# 2024 Field Manual with 2025 updates

Note: Page number is based on 2024 Field Manual with 2025 updates on website.

#### Quick Assessment Chart for SNBI Table 20

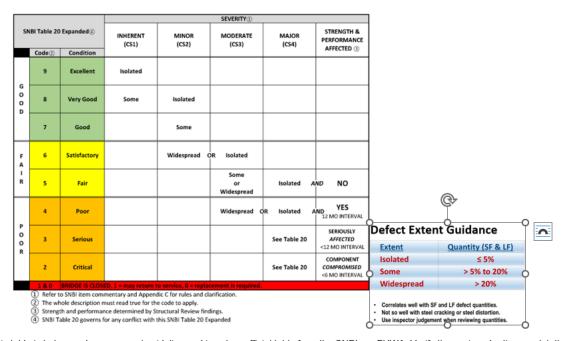
## 17. Chapter 9 Pg. 219, updated quick assessment chart including defect extent guidance

**Note:** This table is to be used as a general guideline and is not an official table from the SNBI nor FHWA. Verify the assigned ratings match the SNBI Table 20.
